City of Rockport

CITY COUNCIL REGULAR MEETING AGENDA

18. Consider the approval of Construction Change Directive #4 related to the new City Hall project

Consider the approval of Construction Change Directive #5 with Teal Construction related to the new City Hall project (cost pending)

WINDOW HEAD/ ARCHED EIFS PANEL SILL DETAIL 3" = 1'-0" 2

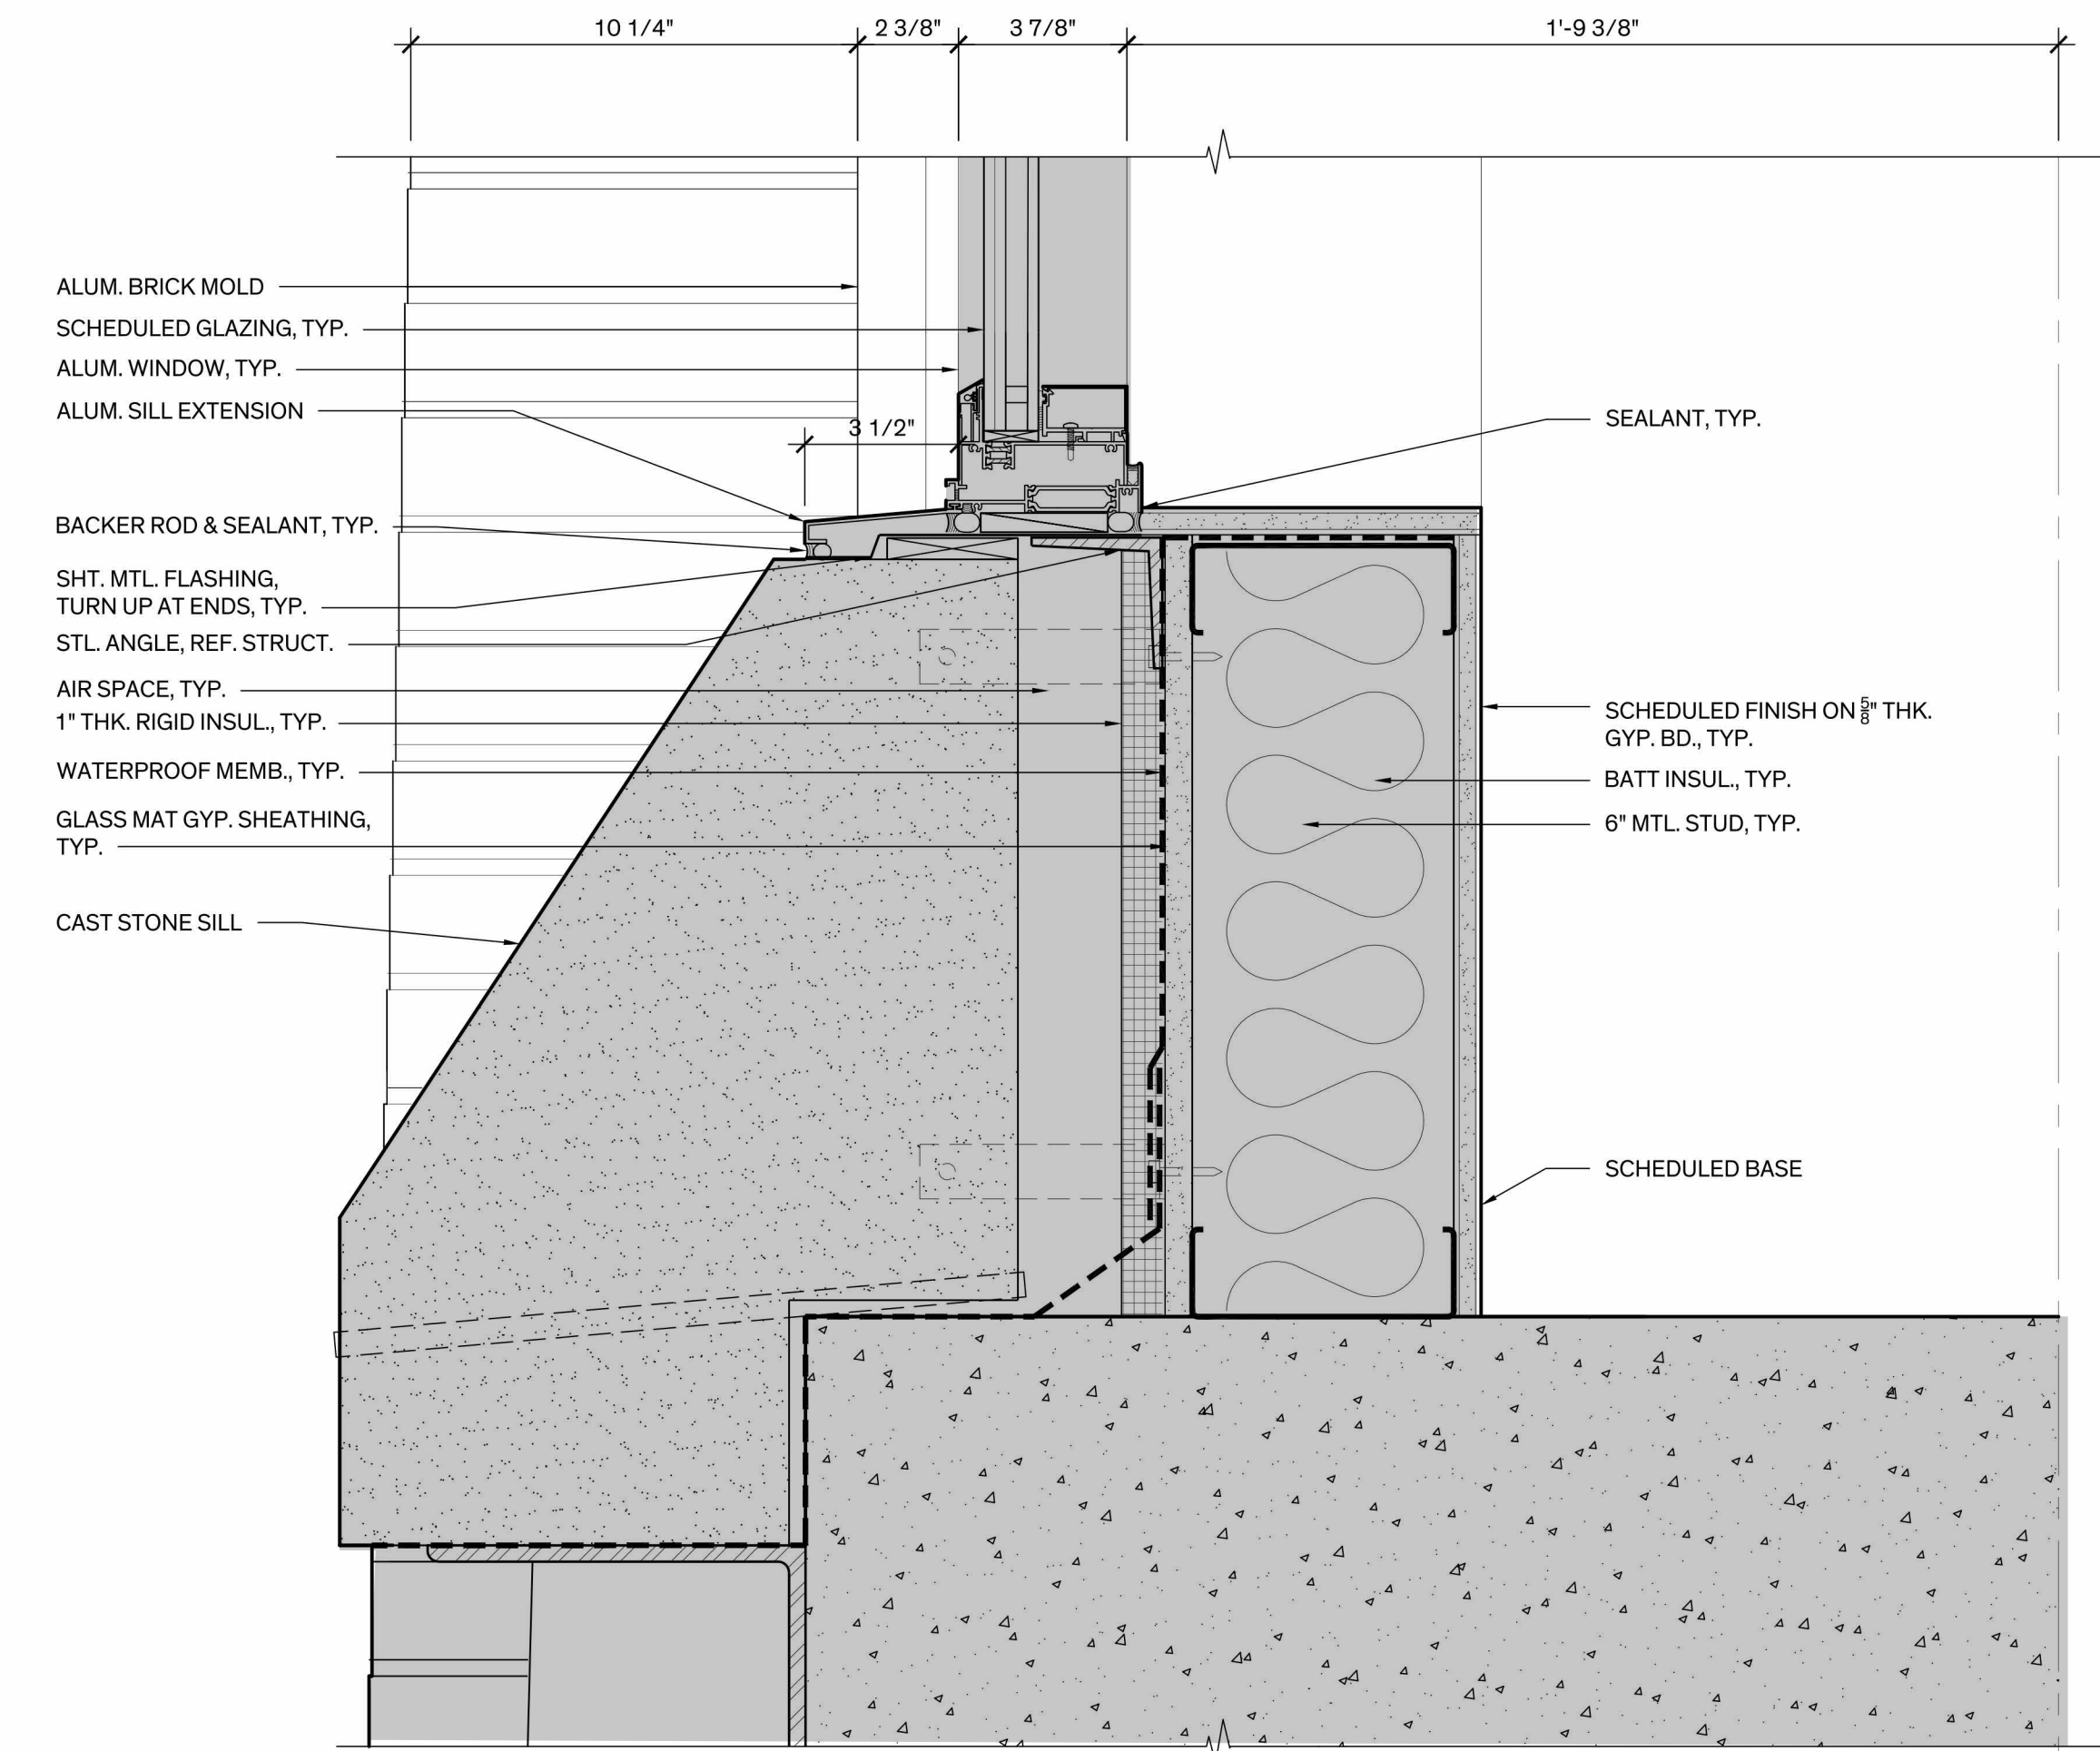
Special infill/reworking of as-built conditions is now required for areas that should have been incorporated with the surrounding metal framed walls per direction provided well in advance of metal framing installation. Had these changes been properly coordinated by the General Contractor, the change in material and labor would have been negligible, especially given the elimination of arched framed openings, etc. Teal is therefore responsible for all metal framing costs associated with this change request.

-The change from full height arched to reduced height rectangular windows with metal framed wall and decorative panels above was made during window shop drawing review dated 11/22/22. Teal did not coordinate the change with other affected subcontractors.

-The area was further documented in RFI 82 dated 2/7/23, see SK-3A through 3D.

-Architexas noted the missing framing and window head for the rectangular window openings in metal framing shop drawing review dated 2/22/23.

-Construction of metal framing and window openings proceeded in conflict with design team direction. Architexas noted the incorrectly built window framing in Field Report 12 from site visit on 1/3/24 and referred back to RFI 82.

-Teal continued construction of the tower exterior envelope and window openings with incorrect conditions and did not issue RFI 168 until 7/16/24.

-Teal did not coordinate the infill panels designed for the area above the rectangular windows (SK-1 provided 11/22/22 with window shop drawing review) and sequencing of surrounding construction. Infill panels needed to be coordinated prior to proceeding with waterproofing and finished masonry openings. Teal is responsible for all masonry removal and reinstallation required in this change request.

Provide EIFS infill with recessed panel detailing within arched openings above tower windows. Refer to attached revised SK-3A, SK-3B, SK-3C, SK-3D, and new SK-3E.

REMOVE
AS-BUILT TO REMAIN
INFILL REQUIRED AT EIFS PANELS
REINSTALL REMOVED COMPONENTS
